**CITY OF BEND PLANNING DIVISION
TYPE II ADMINISTRATIVE DECISIONS**

PROJECT NUMBER: PLSPR20230010

REQUEST: Type II Site Plan review application for a new 14,600 square foot, 3-
story Micro Unit Development in the RM Zone. Twenty-nine units and
18 parking stalls, and associated site improvements are proposed.

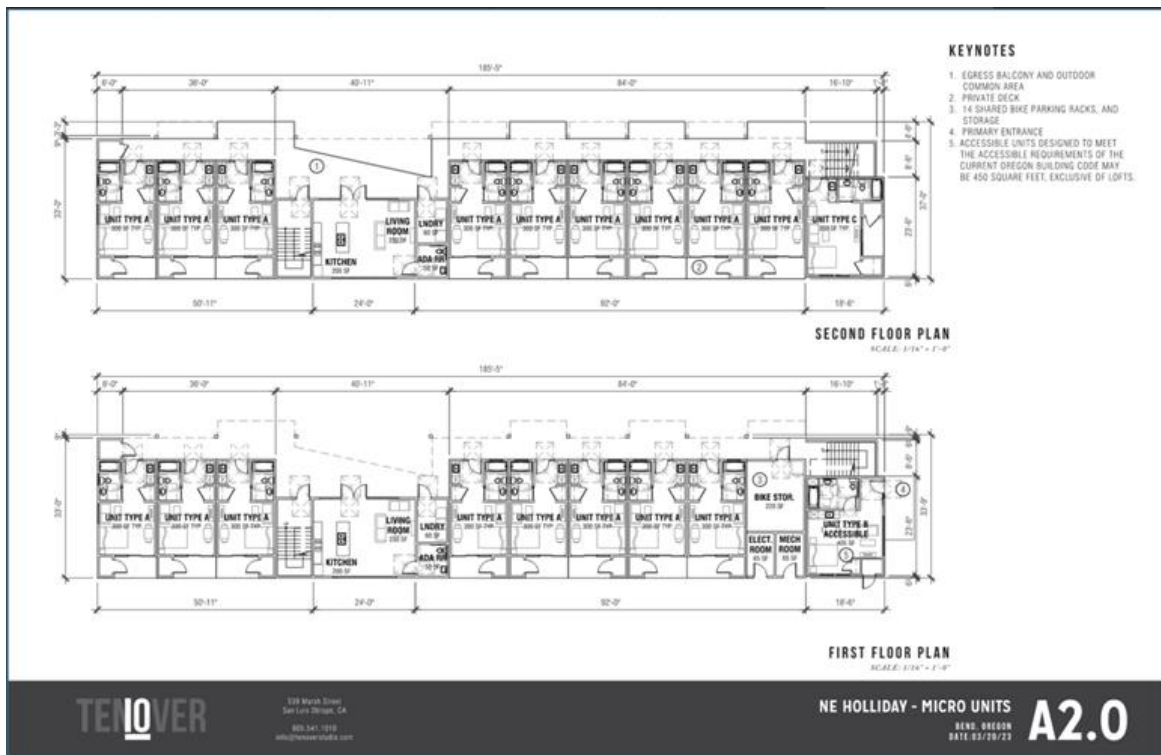
FINDING: The Enlarged Unit Types plan submitted indicates that each unit will be improved with the required amenities per this section. There is an under-counter refrigerator adjacent to the sink, with a counter prep-area at least 4 square-feet in size. The bathroom contains a toilet and a shower/bath. The submitted narrative indicates that the units contain the required elements above, which include the 20-amp appliance branch circuit above the countertop. These standards are met.

Block Length

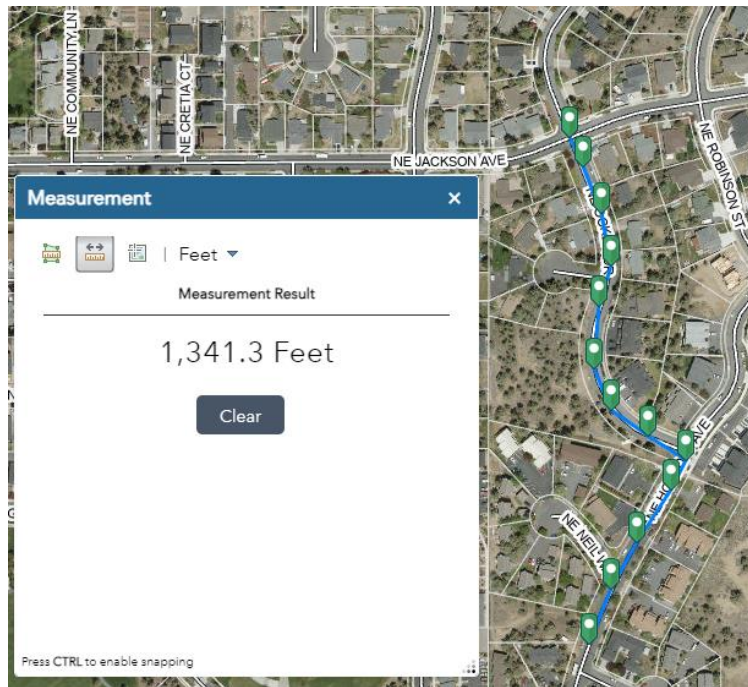
FINDING: The subject property does include a pedestrian connection to the property to the west through an existing access easement. As a Condition of Approval the applicant shall grant a public access easement along the proposed walkway through the site. The subject property is within the Residential Medium Density Zone. The block length is about 1,341 feet which exceeds the 660 foot block length maximum. The perimeter is about 4,914 feet which exceeds the 2,000 foot block perimeter maximum. The walkway to the western pedestrian connection will reduce out of direction travel due to the large block length and perimeter.

Condition of Approval: Prior to occupancy the applicant shall grant a public access easement along the walkway through the site to connect to the existing public access easement through the townhome development to the west, which connects to the public sidewalk along NE Moonlight Drive.

Site and Utility Plan

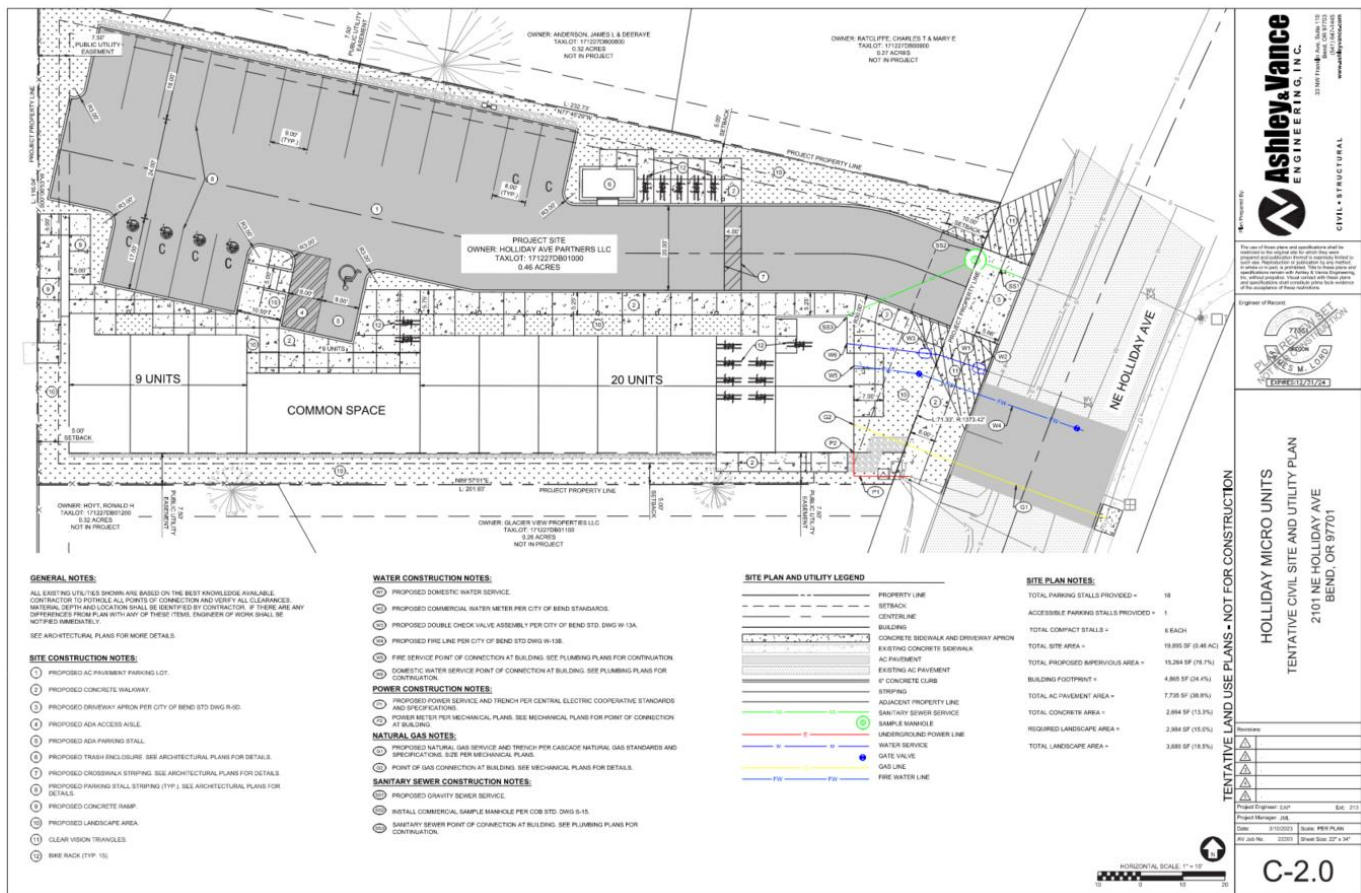
FINDING: The Private Development Engineering Department reviewed the existing water/sewer services and noted that the development can continue to be served by the 4-inch PVC sewer lateral. If the Engineer of Record determines that a larger lateral is needed, then the existing lateral must be abandoned and removed from the right of way. A new lateral must be extended to the property that meets City of Bend Standards. All lateral extensions and abandonments must be done through a Right of Way Permit. Only one lateral is allowed per lot.

During the building permit review, the development must provide a fixture count for the entire site, including the proposed development. The size of the meter will be verified by the City to determine that the water meter will sufficiently serve the buildings. If the water meter is determined not to be large enough the development will be required to upsize the water meter and/or water lateral.

Condition of Approval: During the building permit review, the development must provide a fixture count for the entire site, including the proposed development. The size of the meter will be verified by the City to determine that the water meter will sufficiently serve the buildings. If the water meter is determined not to be large enough the development will be required to upsize the water meter and/or water lateral.
